REQUEST

Current Zoning: N1-A (neighborhood 1-A)
Proposed Zoning: N1-F(CD) (neighborhood 1-F, conditional)

The petition proposes to develop two triplex buildings and one quadplex on two parcels currently developed with two single family detached homes.

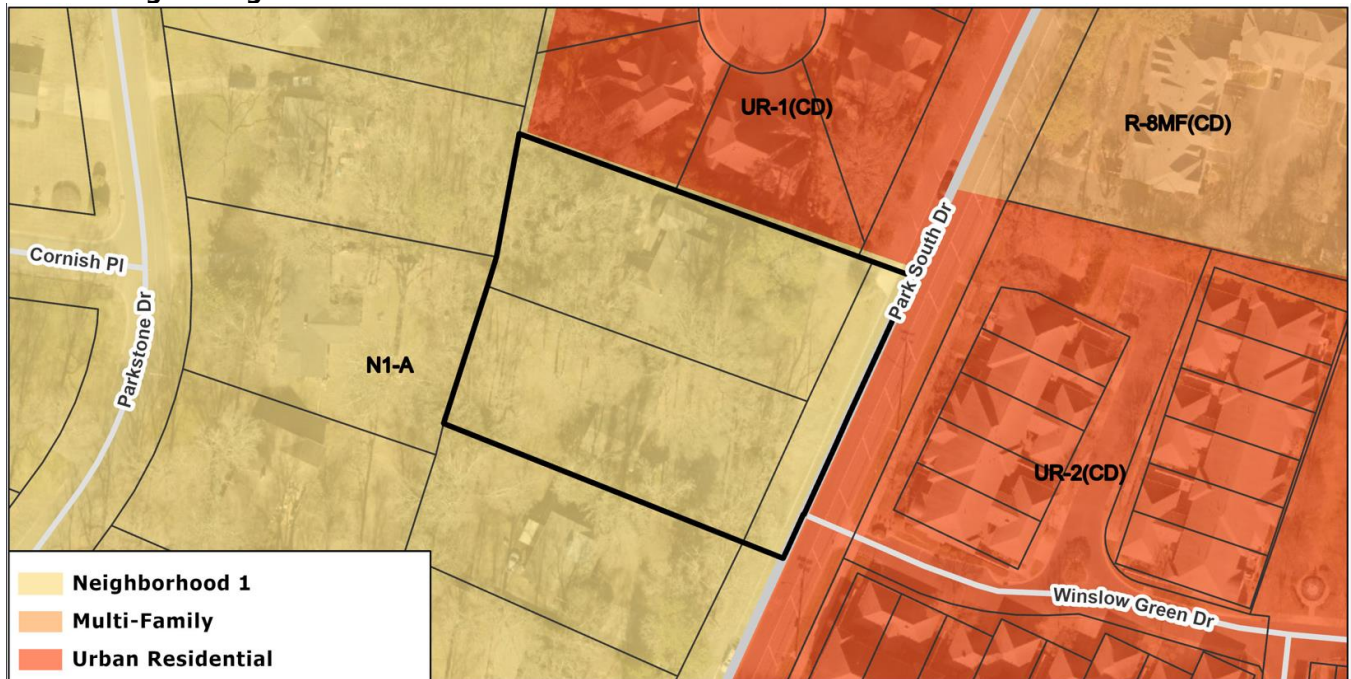
2. ~~Clarify if the tree save area shown on the site plan is outside of the demolition plan.~~ **Addressed**
3. **The replanted tree save area will have to be at a higher rate than the required minimum of 15% of the site. Increase the proposed tree save on the plan.**
